SEWAGE DISPOSAL SYSTEM

HOWARD COUNTY HEALTH DEPARTMENT

SUBDIVISION _____ LOT _____ ROAD 3626 Church Road

REPAIR - PURPOSE - SEPTIC SYSTEM HAS FAILED.

A P 50908

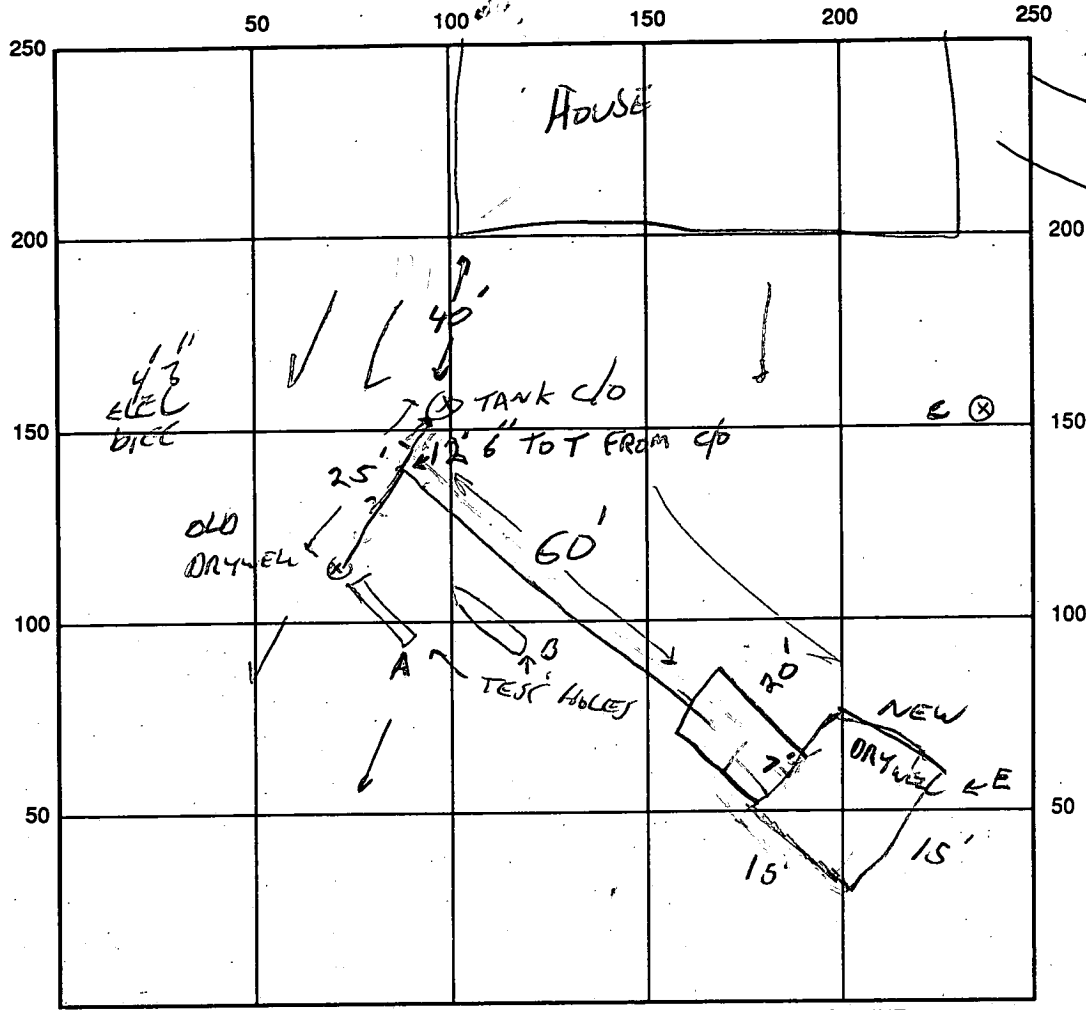
REMARKS: 9/13/95 SEE PERC SHEET FOR TEST HOLE CHANGES 9/14 DID NOT SEE RESTRICTOR

-IN LINE, FLOW CORRECT, DRYWELL INLET AS 3' MAX DEPTH 10' 7' CONC
UNDER PIPE SHORT TRENCH TO OLD S.T., FLOW RESTRICTOR/REGULATOR
IN LINE TO OLD DRYWELL, LOCATED AT T W LINE TO NEW DRYWELL

INSTALL DRYWELL AT LOCATION DISCUSSED ON SITE. DRYWELL SHALL BE 15'x15', MAX DEPTH 10', INLET AT 3' RUN A SHALLOW TRENCH FROM DRYWELL TOWARDS SEPTIC TANK AS SOIL CONDITIONS ALLOW.

P
17614

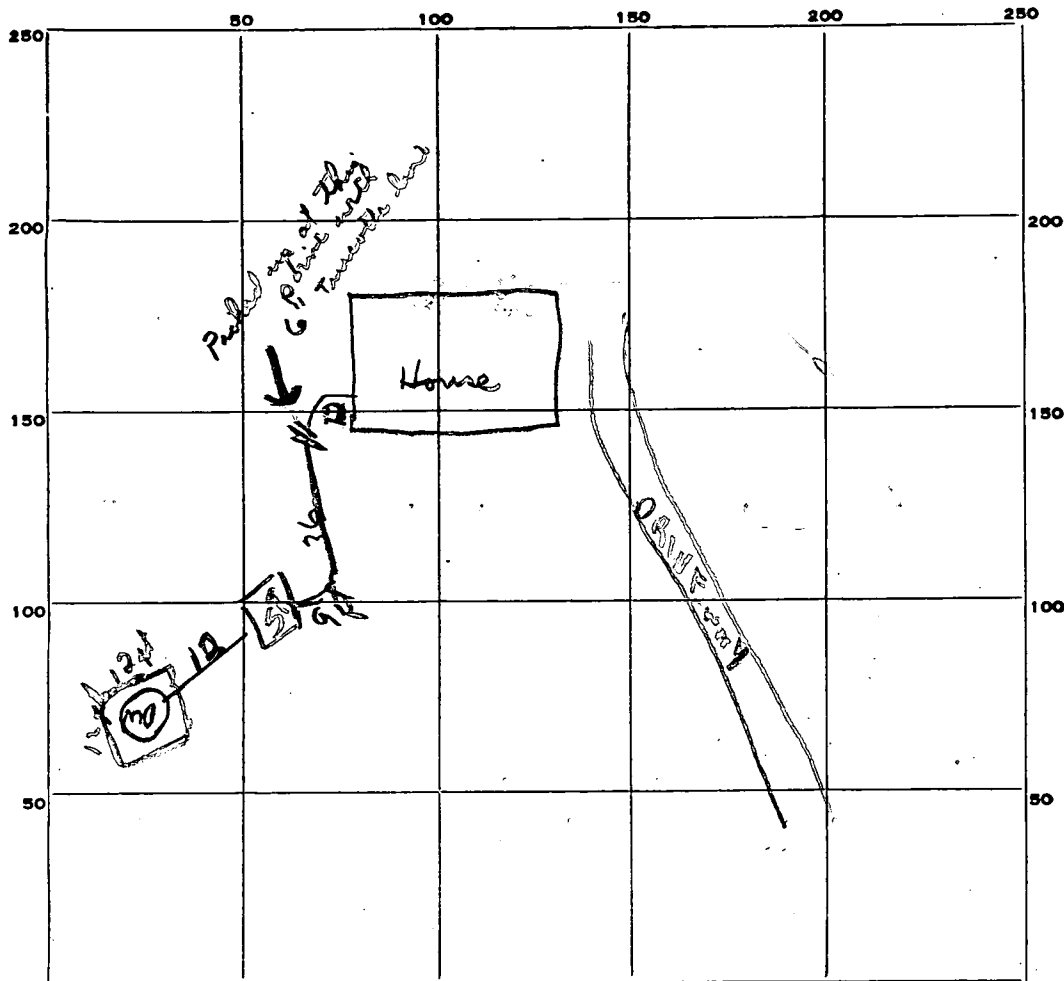
REMARKS 11/8/72 - A few more trench slots needed; also cleanouts.

OTHER REPAIR - Owner requested dry well installed (no problem). Mr. Robinson will install the dry well. If any problems encountered he will immediately stop work and call the Health Department.

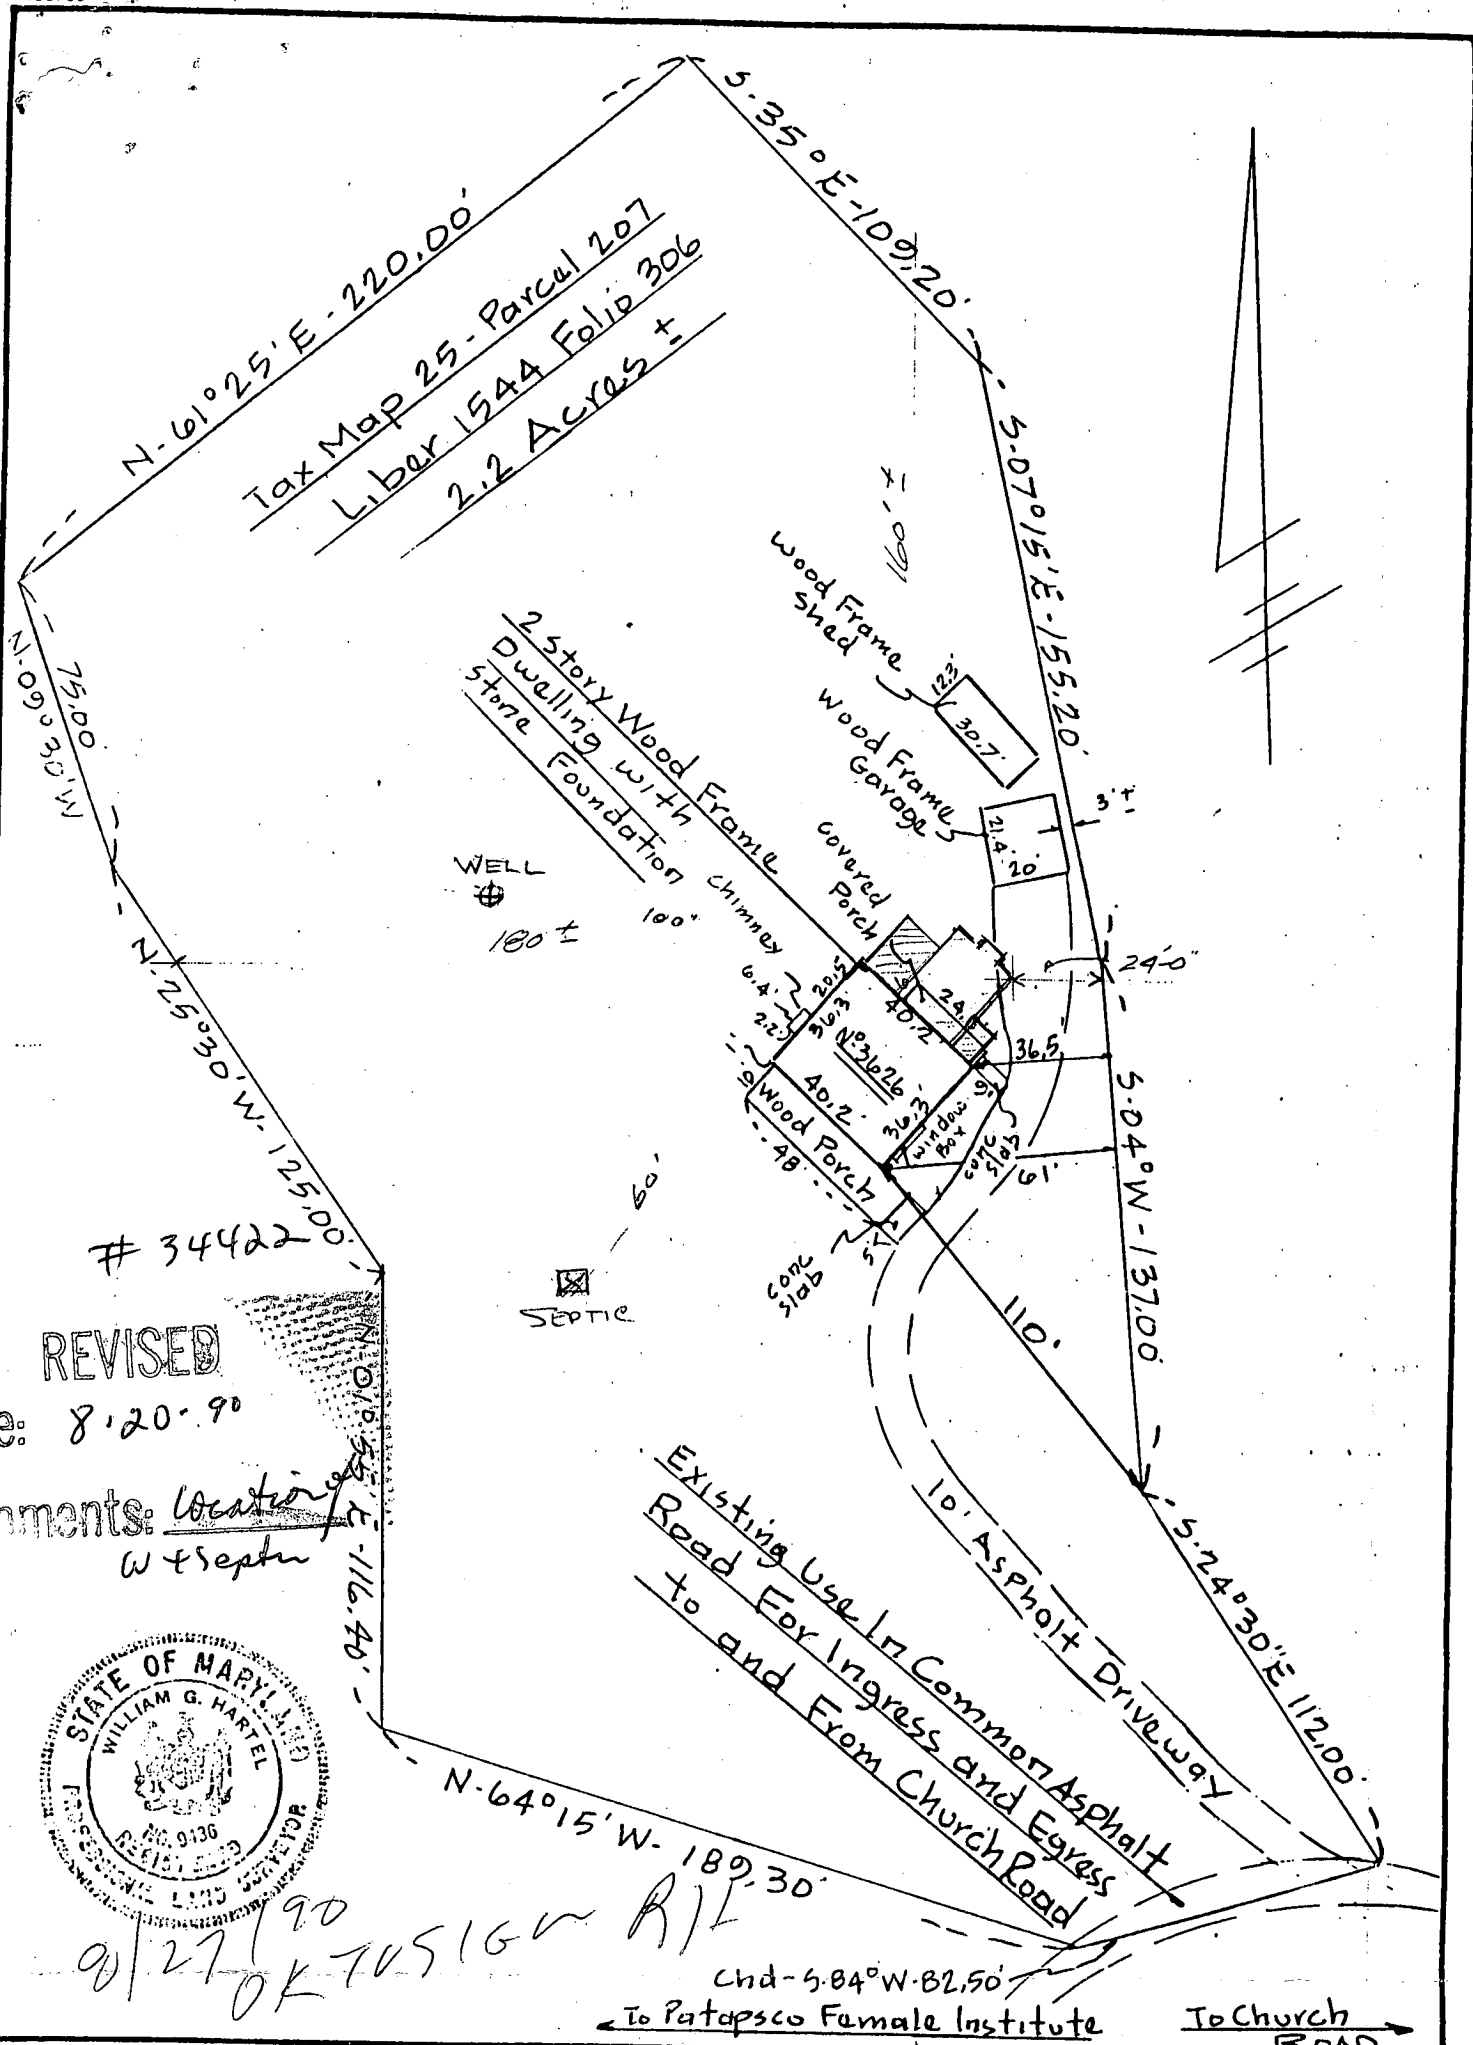
Comments: Location w/ Septic

9/27/90
 OK 70516 w R/L
 Chd - S-84°W-82.50'
 To Patapsco Female Institute To Church ROAD

Location Drawing

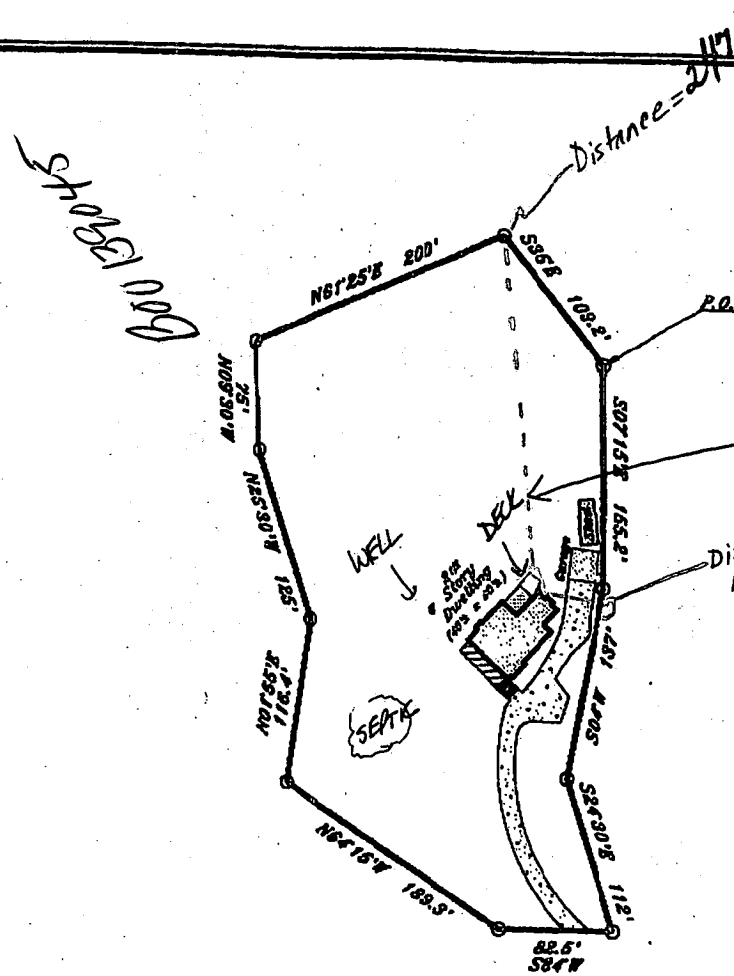
10/24/02
proposed
deck
OK (SRK)
